Addendum

DSP56303UMAD/D
Rev. 0, 05/2002

DSP56303 User's
Manual Addendum

Figure B-2. Operating Mode Register (OMR)

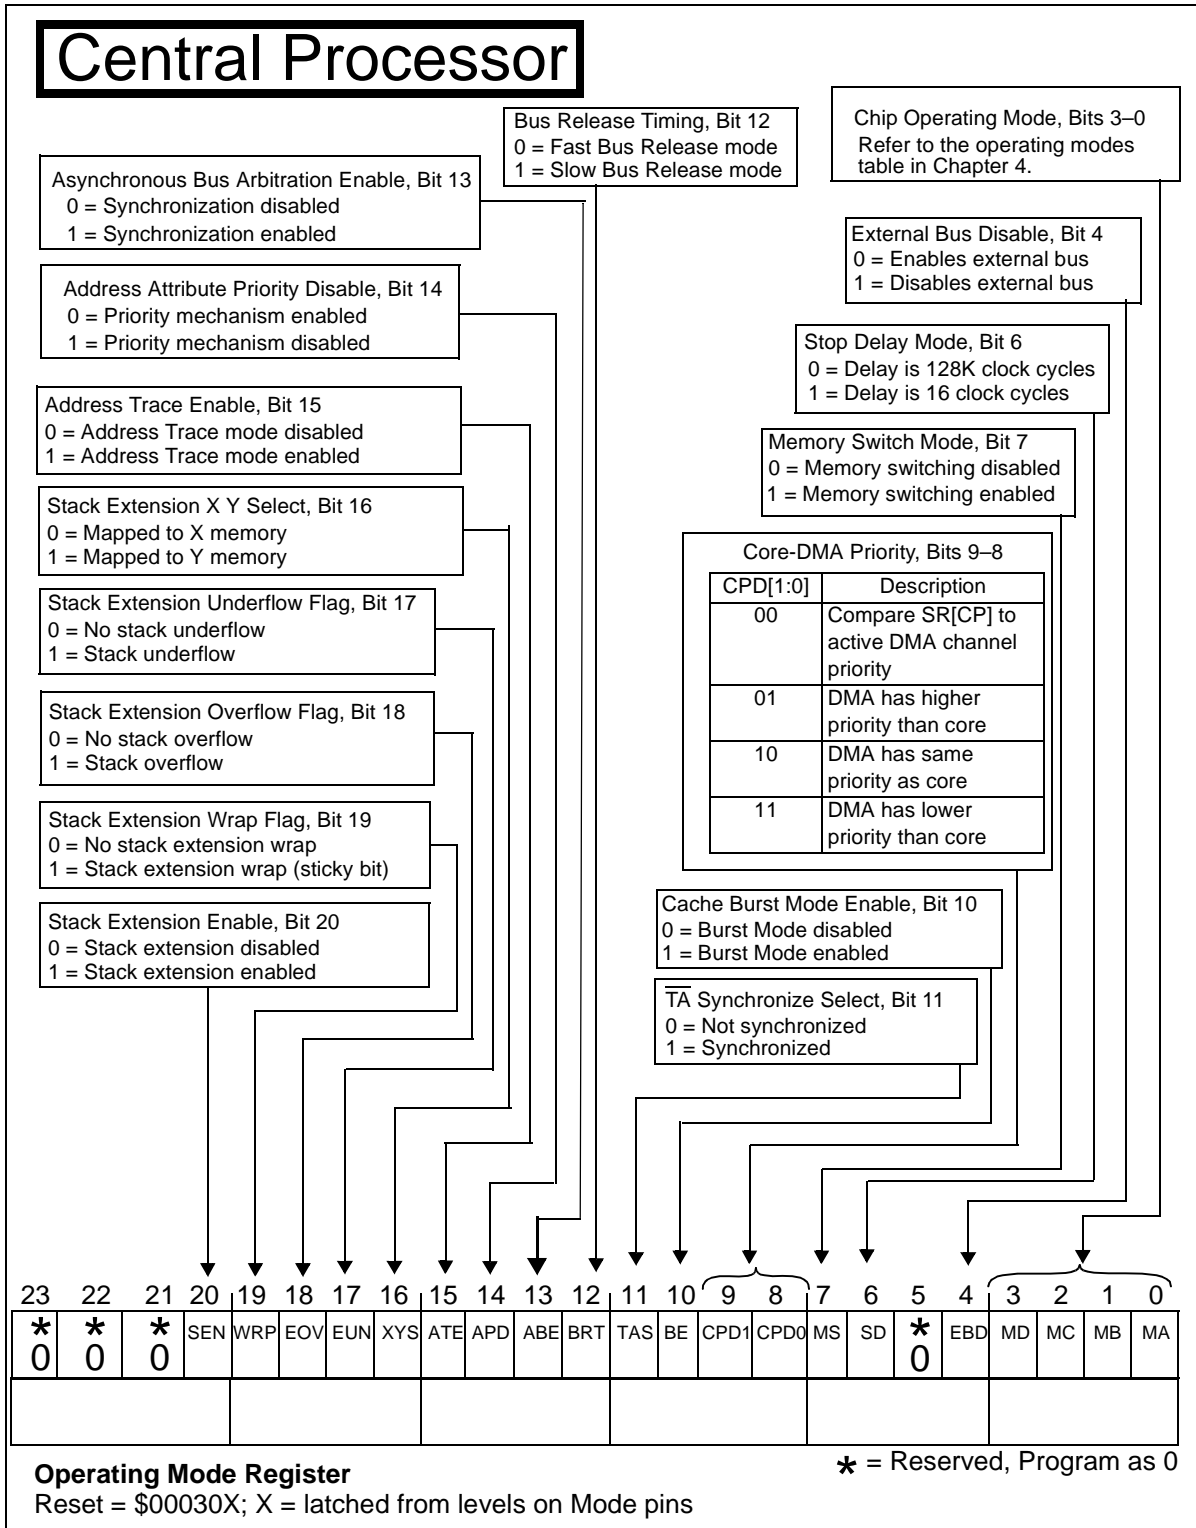
Use the following examples to replace **Figure B-2** (p. B-13), **Figure B-6** (p. B-17), and **Figure B-8** (p. B-19).
